**PROJECT: Multi-Sport Venue in Eastern New Orleans and Lower Ninth Ward
4290 Almonaster Avenue,
New Orleans, LA 70126**

ADDENDUM NO. 6

July 2, 2025

This Addendum forms a part of the Contract Documents and modifies the Project Manual – Volume 1 and 2, and Drawings dated January 30, 2025. Clarifications and revisions noted below are in response to the project solicitation posted on May 29, 2025.

CIVIL DETAILS

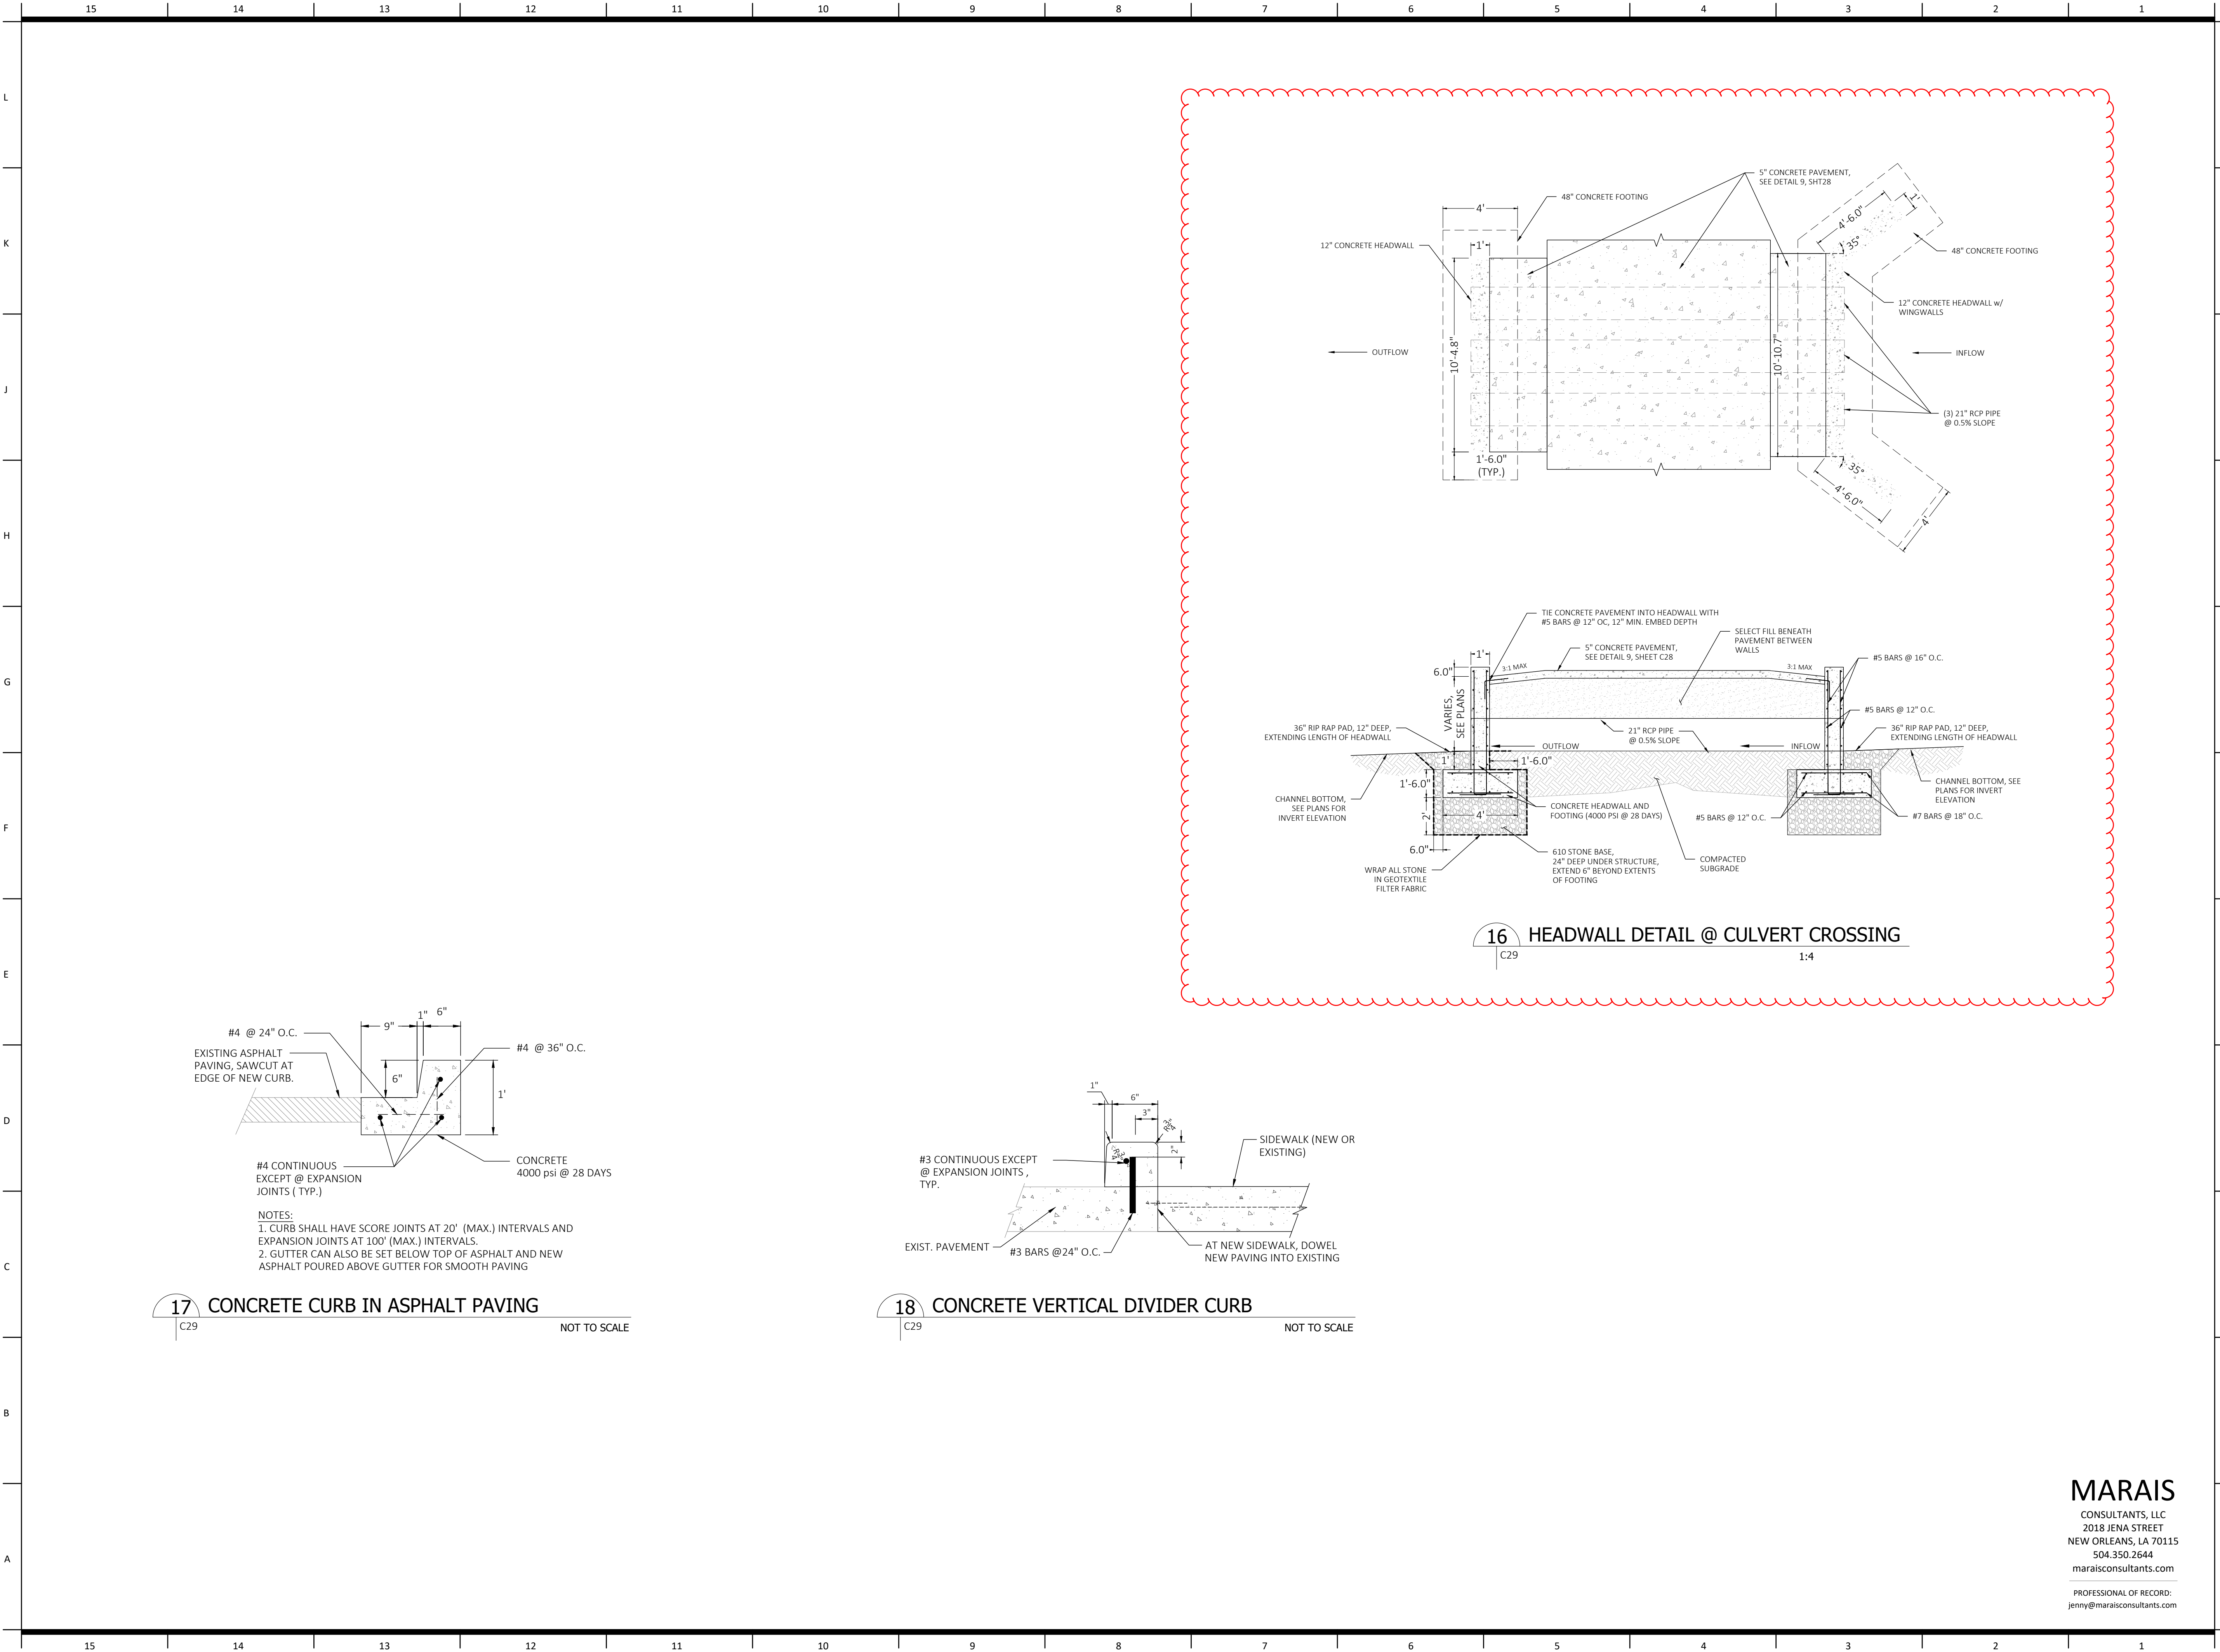
7. Can you please provide dimensions for the headwalls and the height, length, and thickness of the 24" concrete footing under the headwalls on detail 16 sheet C29. This detail also references detail 9 on sheet C19, which does not exist.

- This has been revised on the attached sheets.
8. Detail 8 on sheet C27 is not to scale and does not show dimensions for the coverage of compacted 57 stone over the perforated pipe, the base course stone, finish grade stone, nor the concrete curb. Can you please clarify what thicknesses each of these layers should be? Further, sheets C14 and C15 do not indicate a perimeter curb around the field. Is detail 8 standard for the entire perimeter of the football field? Will this curb tie into the 5" concrete concourse around the field?

- Updated detail to show layer thickness for gravel. Yes the detail shows the typical edge condition for the turf. Assume a flush curb around the entire perimeter of the field. The curb can be poured separately or monolithically with the adjacent concrete pavement.

BUILDING
FOUNDATION &
FRAMING
S101

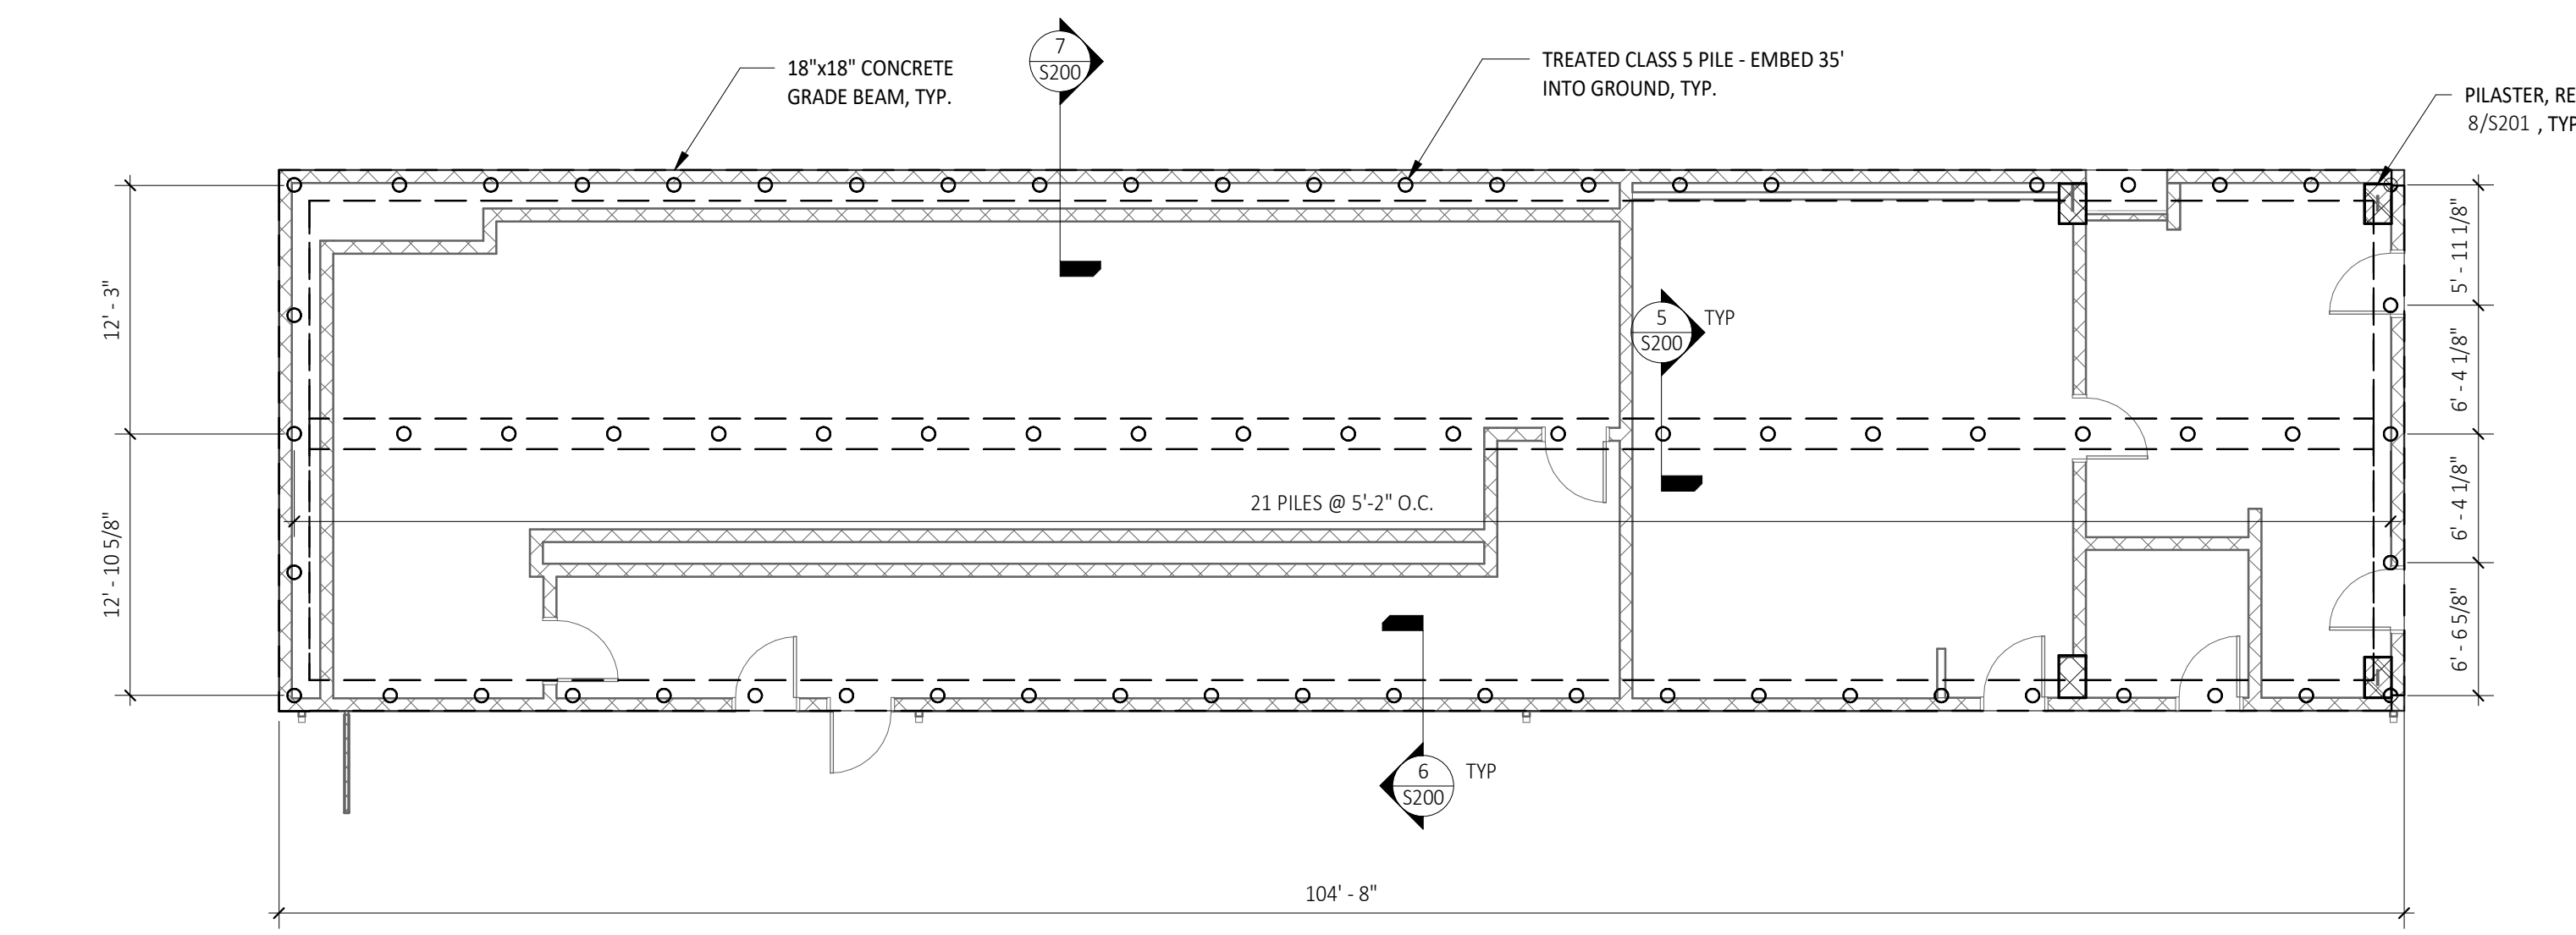
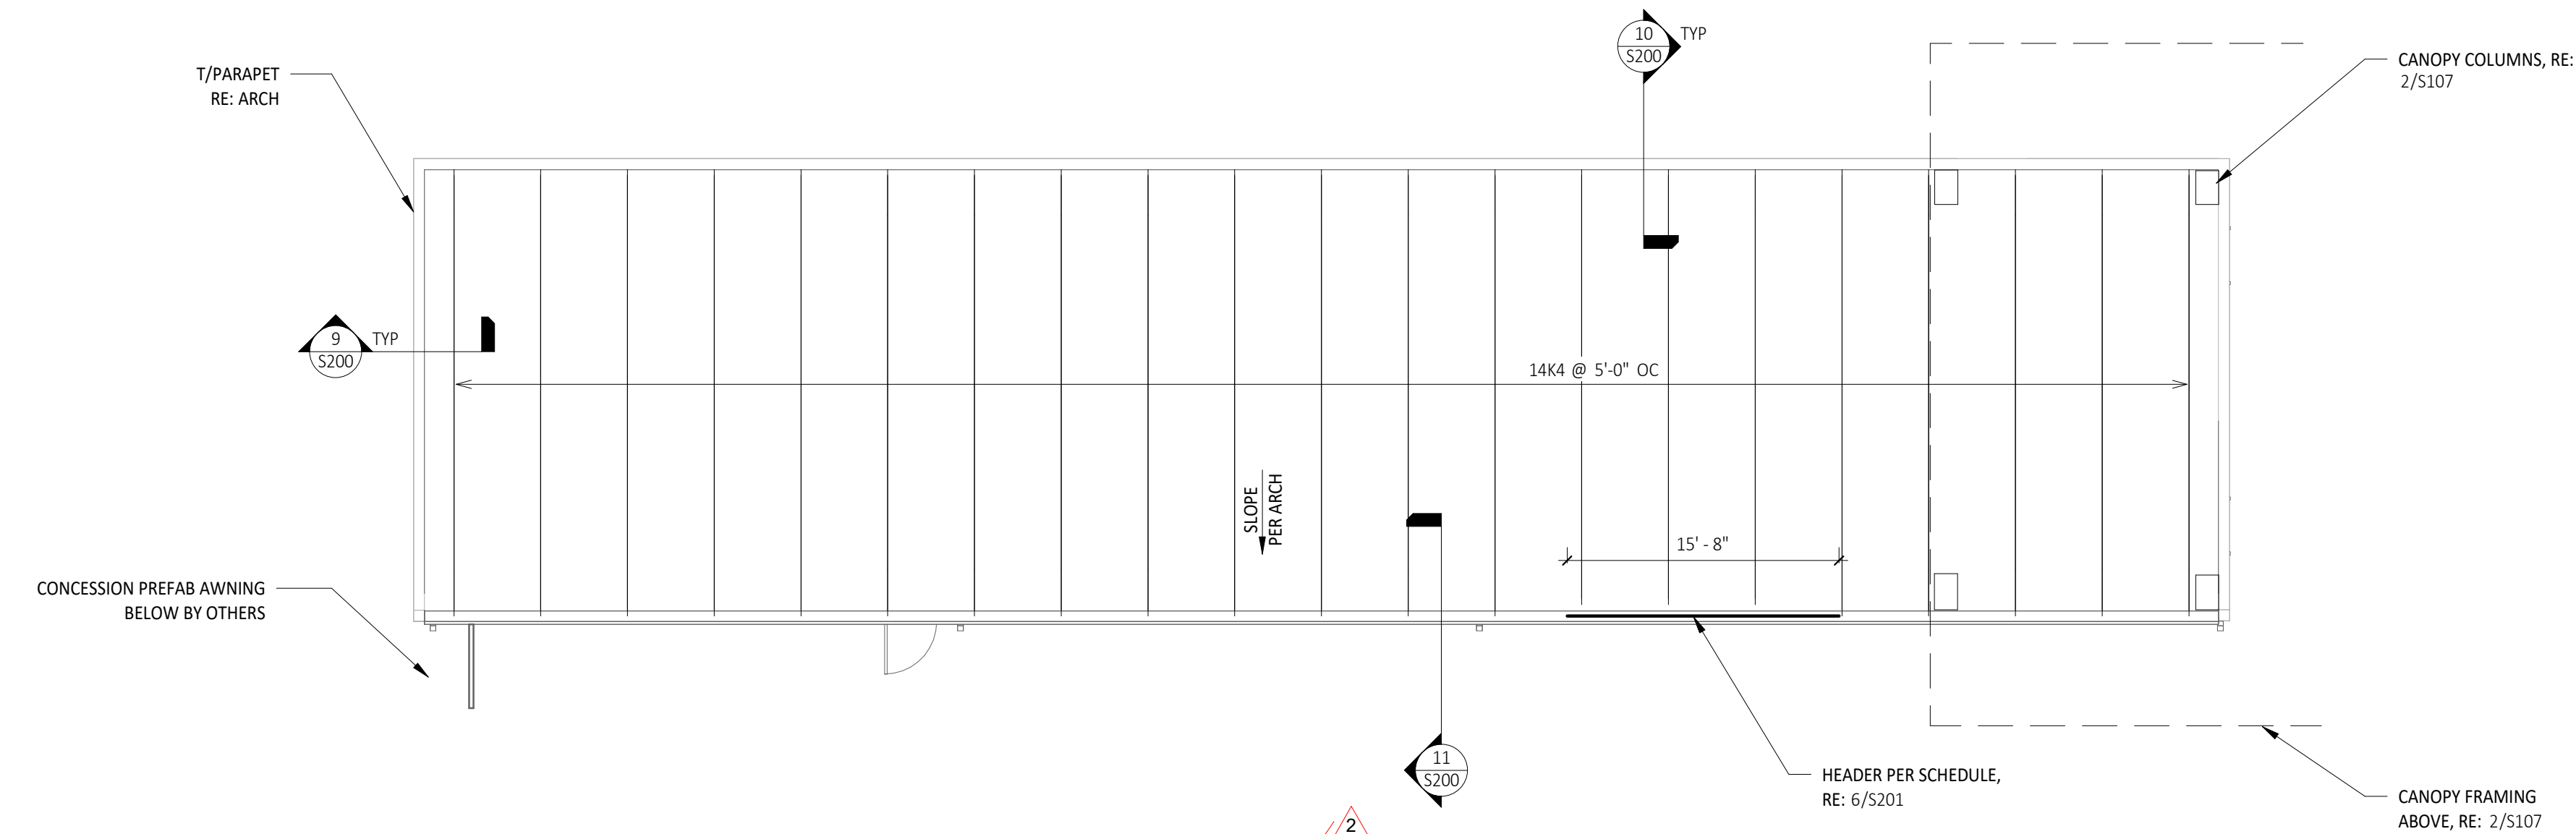
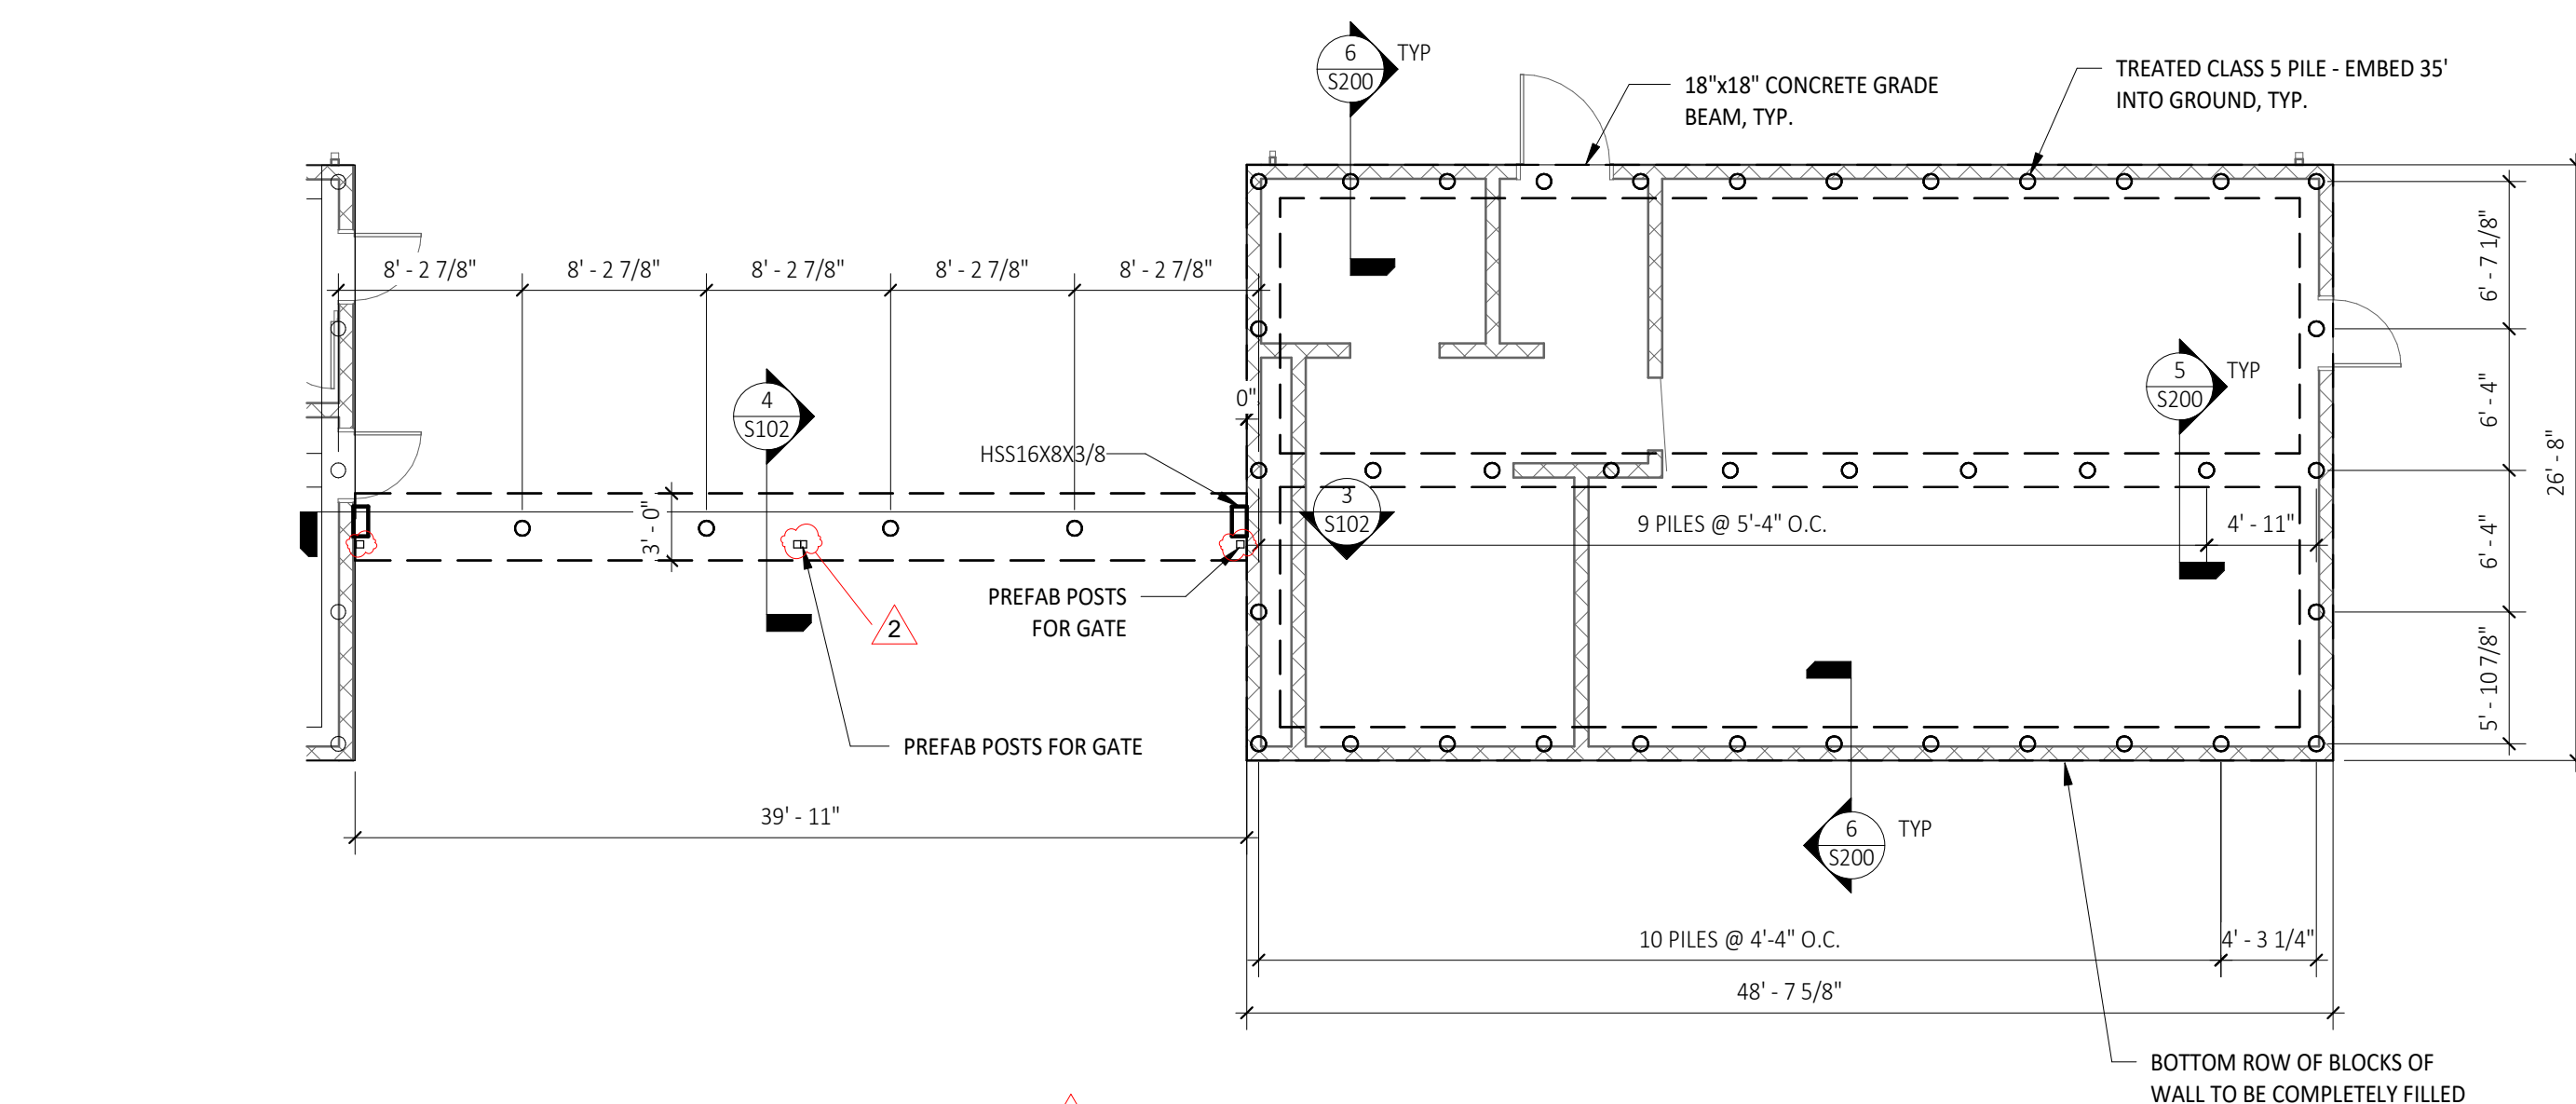
- The drawings show the design intent for the Away Bleachers with gravel between grade beams.
13. Can you please identify the building foundations shown on sheets S100, S101, S102, and S103 for clarity. They are all labeled as "Building Foundation Plan" with no references to the site plan.

- Labels have been updated in attached revised structural sheets.
14. There are two call outs for prefab posts for the gate, but it is not clear what it is pointing to.
